CITY OF BOULDER LANDMARKS BOARD MEETING

DATE: Wednesday, December 2, 2015

SUBJECT: Public hearing and consideration of a Landmark Alteration Certificate application to demolish an existing house built in 1957 and, in its place, construct a new 2,500 sq. ft. house at 2110 4th Street in the Mapleton Hill Historic District, per section 9-11-18 of the Boulder Revised Code (HIS2015-00254).

Figure 14. Proposed Site Plan

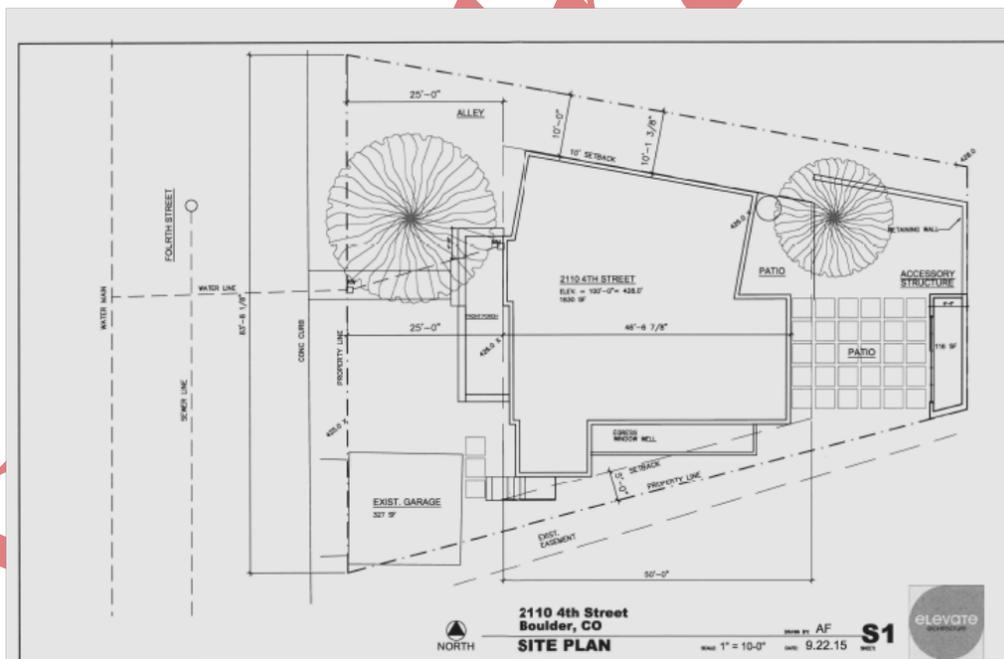
In plan, the proposed new house is shown to be located at approximately the same location as the existing house. The existing house is located approximately 26' from the west property line and the proposed house is shown to be located at the 25' front yard setback. The existing house measures approximately 35' wide and 26' long, with a 21'

by 8' shed-roof portion located at the rear of the house. The proposed house is shown to measure 46'-6" long and approximately 50' wide with the north wall creating an oblique angle running parallel to the north property. Currently the alley provides access to at least one property to the east. The existing contributing garage is shown to be maintained in its current location.

The site plan indicates construction of rear retaining walls, a rear patio and a 116 sq. ft. accessory building, (no elevations provided). No information was provided as to whether any changes to the contributing garage are contemplated as part of this project.

Figure 16. Proposed north (side) elevation

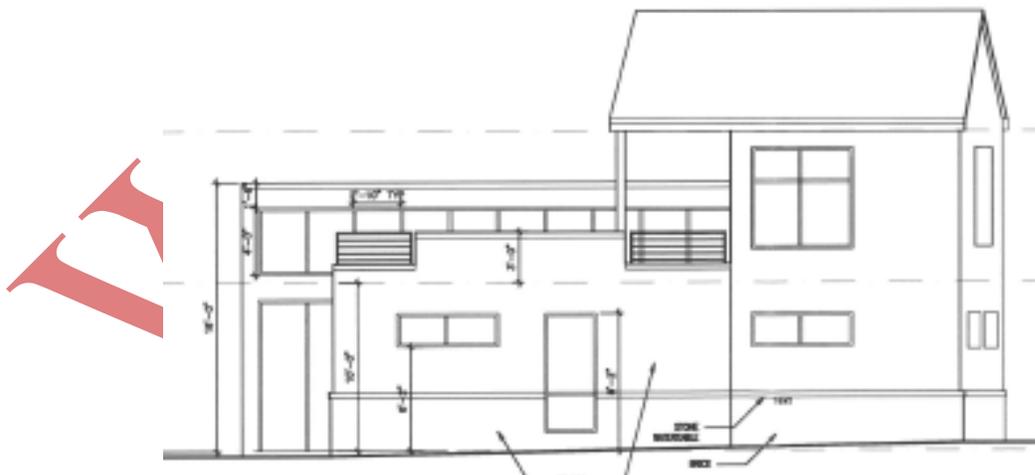
Drawings and renderings show the façade to feature three building forms: a vertical, front-gable portion at the north that is clad in brick, a two-story rectangular form with a flat-roof porch over the entrance, a cubic volume clad in brick, and a lower, flat roof

On the north elevation, the gable roof form measures 17', of which 7' of this roof serves to create a sheltered area over part of the 200 sq. ft. rear roof deck area.

Specifically, the multiple forms, truncated gable tower and oblique building angle at the north will all be highly visible and alter character of the site in a manner that will be incompatible with streetscape and southwest section of Mapleton Hill. The building form should be simplified to reflect the proportion of historic buildings of similar size found in the district. The window proportion, spacing and scale should be revised to reflect traditional patterns found in the district. Similarly, the material palette should be

revised to eliminate the metal roofing and oil copper fascia and proposed traditional roofing material and painted wood siding.

Figure 17. Proposed south (side) elevation

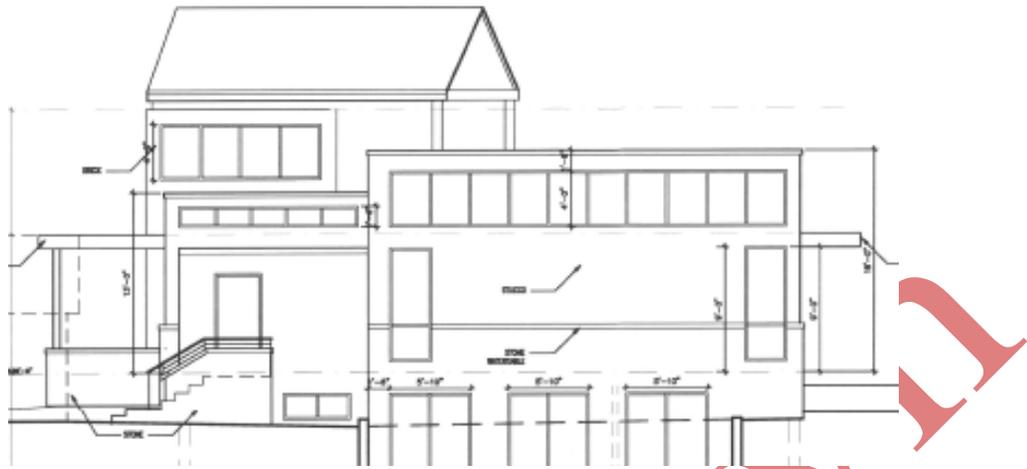
Elevations show the façade of the house to be fenestrated with a picture window, one over one double-hung sash, casement windows and a row of six horizontal clerestory windows. The sides and rear of the house are shown to be fenestrated with double hung sash, casement windows and banks of clerestory windows similar to those shown on the façade.
